TO: Mayor Robert Price, City of Locust Grove
ATTN TO: Anna Williams, Planner II, City of Locust Grove
RE: Development of Regional Impact Review
FROM: Mike Alexander, Director, ARC Center for Livable Communities

Name of Proposal: Locust Grove Phase III DRI 3805

Description: A DRI review of a proposal to construct two industrial warehouses totaling 962,220 SF on a 101-acre wooded site with streams and wetlands off of Price Road and Bethlehem Road in the City of Locust Grove in Henry County.

DRI EXHIBIT - SK-1 MASTER PLAN

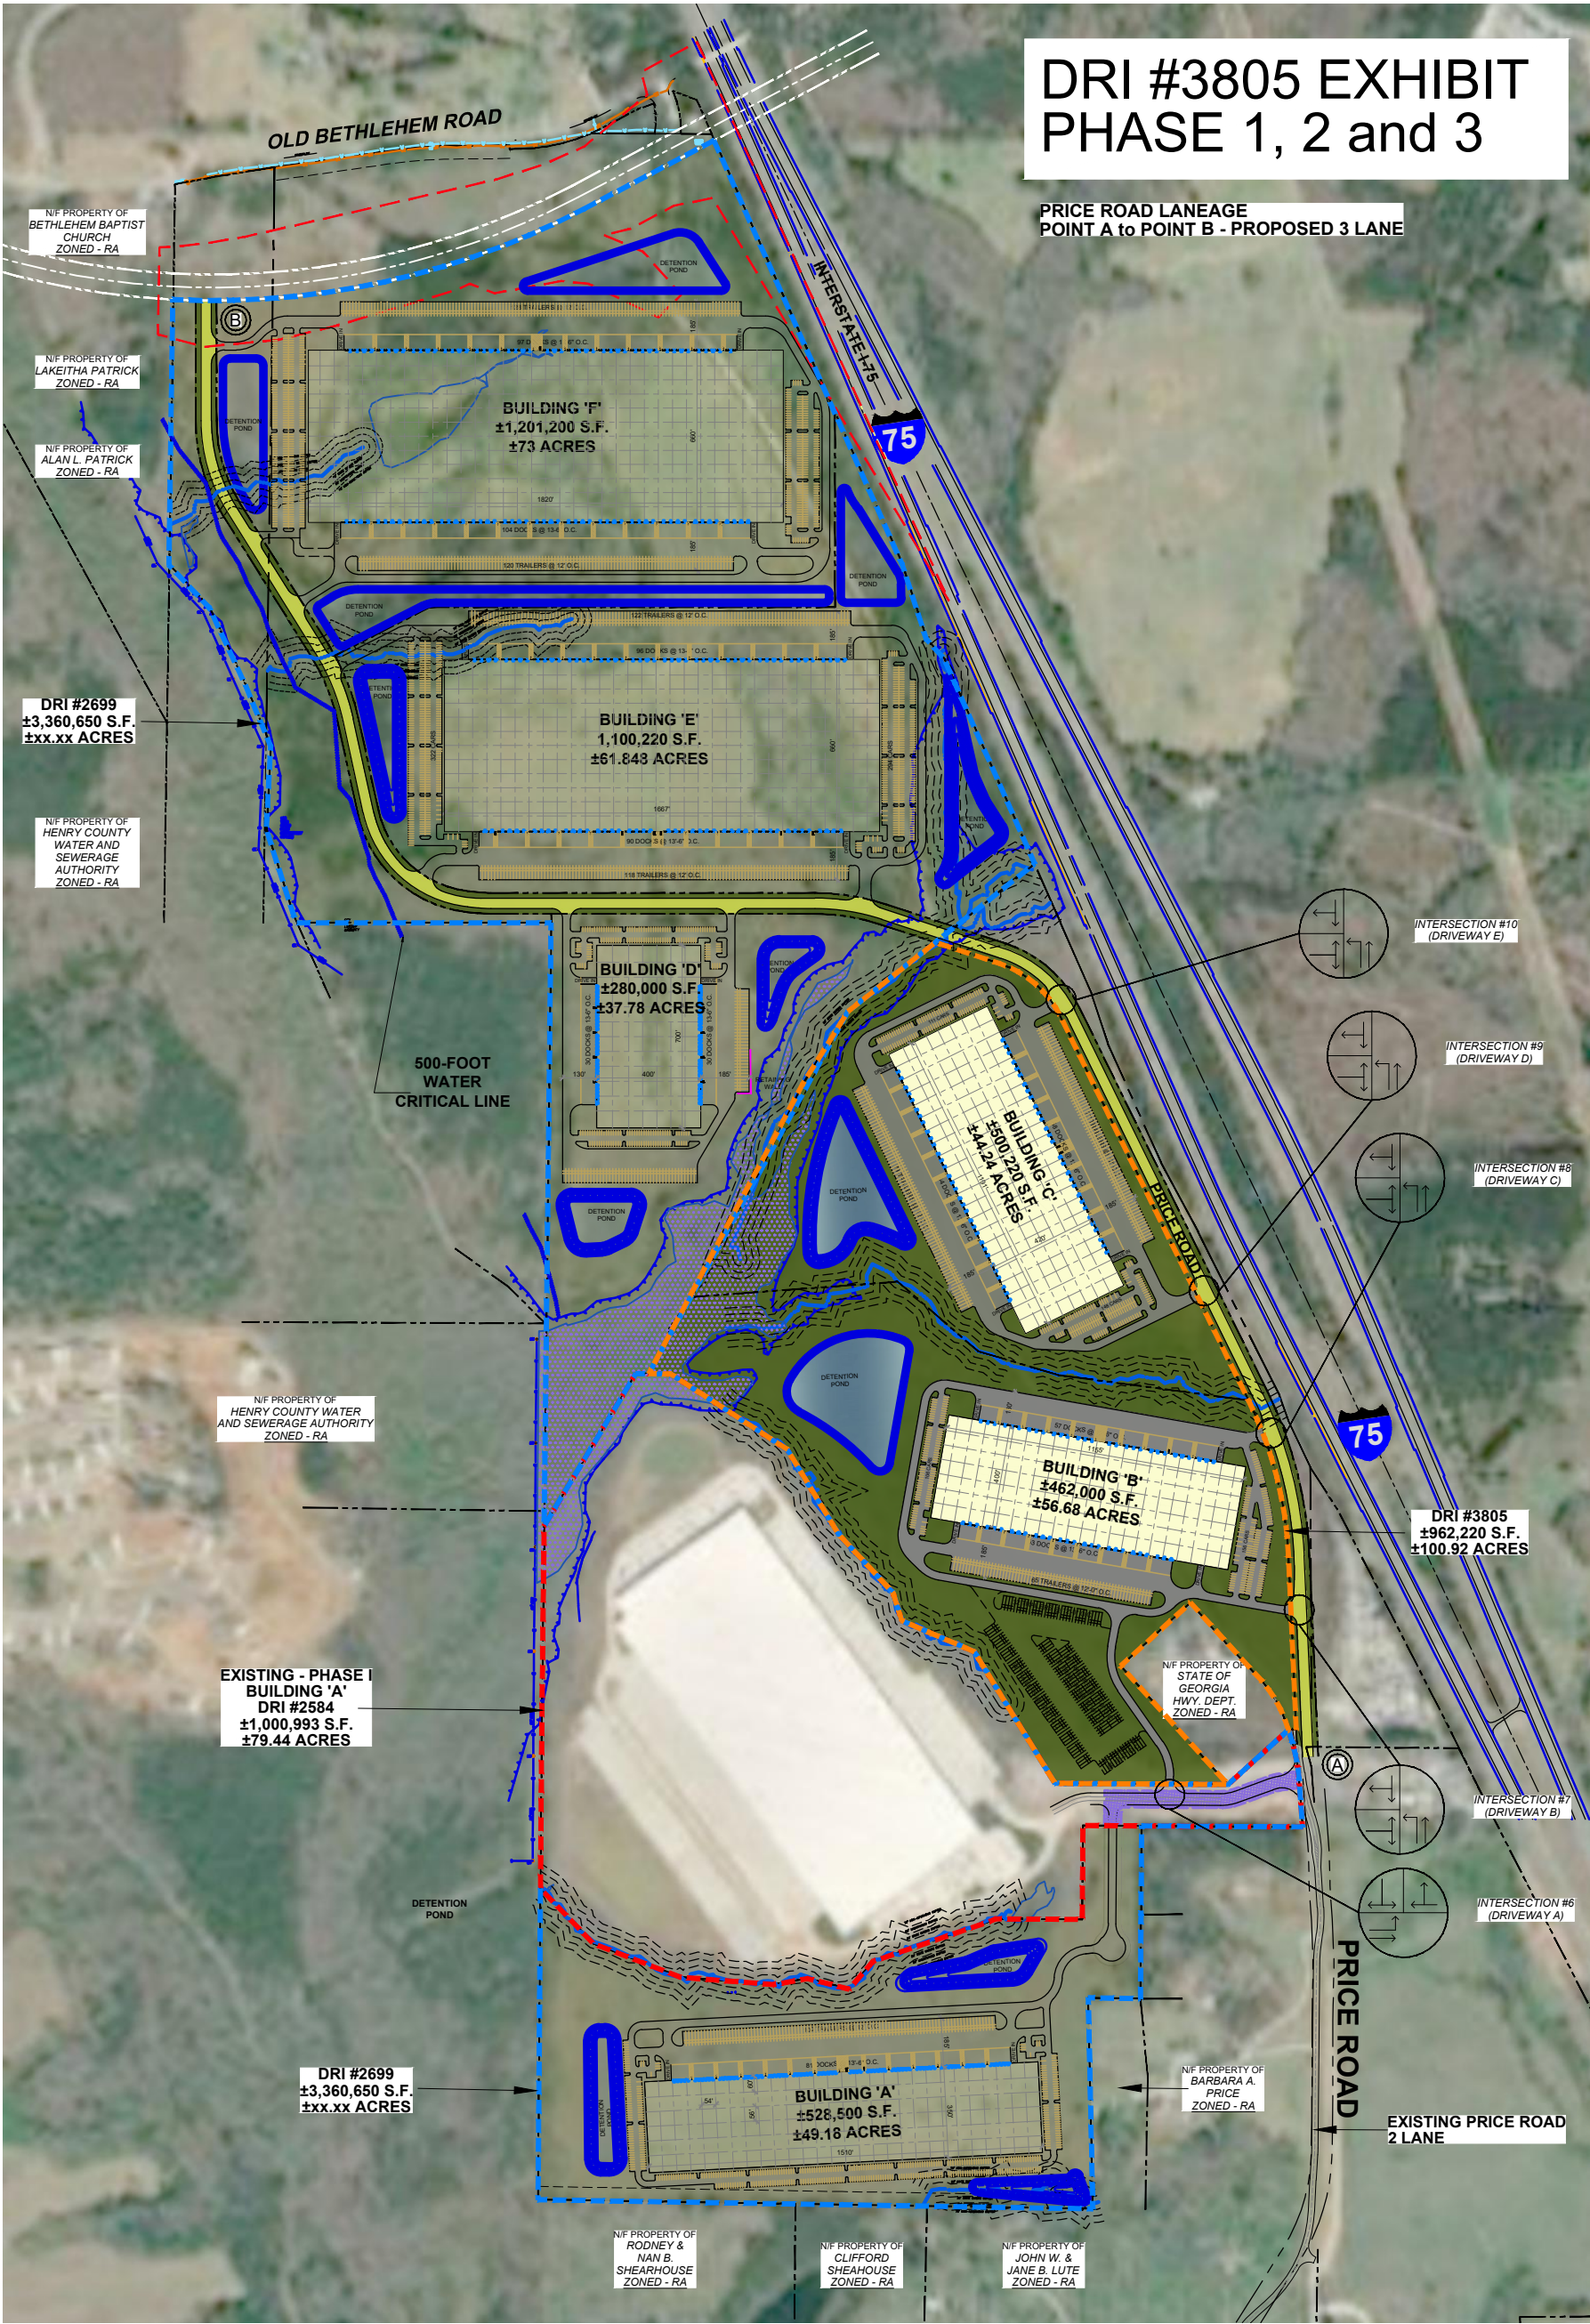
A total of 521 car parking spaces and are proposed which is substantially more than the minimum 200 required. A total of 388 truck trailer spaces and 232 truck docks are provided. No EV charging spaces appear to be identified; provision of adequate EV charging spaces would be supportive of regional EV infrastructure policies.

Incorporation of green stormwater and heat island mitigation designs for the surface car and truck parking spaces proposed would be supportive of regional environmental policies.

Some land around stream buffers is proposed to be retained by the project. Additional retention of these areas would be desirable and in keeping with regional goals regarding carbon sequestration and climate change/heat island effect mitigation. Designation of these preserved areas as managed open/conservation space could meaningfully reduce the overall impact of the project. There may be potential opportunities for linking these fragmented undeveloped areas with adjacent undeveloped or protected areas to ensure their maintenance and potential use for recreation or habitat preservation.

The project can support The Atlanta Region's Plan in general by incorporating other aspects of regional policy, including green infrastructure and/or low-impact design, e.g., pervious pavers, rain gardens, vegetated swales, etc., in parking areas and site driveways, and as part of any improvements to site frontages.

Incorporation of green stormwater and heat island mitigation designs for the surface car parking spaces and other project hardscapes proposed would be supportive of regional environmental policies.

The project is not aligned with the above Developing Suburbs policy recommendations. It could be better aligned through retention/dedication of additional undisturbed areas around the Indian Creek tributary, the provision of a management mechanism for the areas being preserved, and the utilization of green infrastructure in project hardscape areas. City of Locust Grove leadership and staff, along with the applicant team, should collaborate closely to ensure optimal sensitivity to the needs of nearby local governments, neighborhoods, and natural systems.
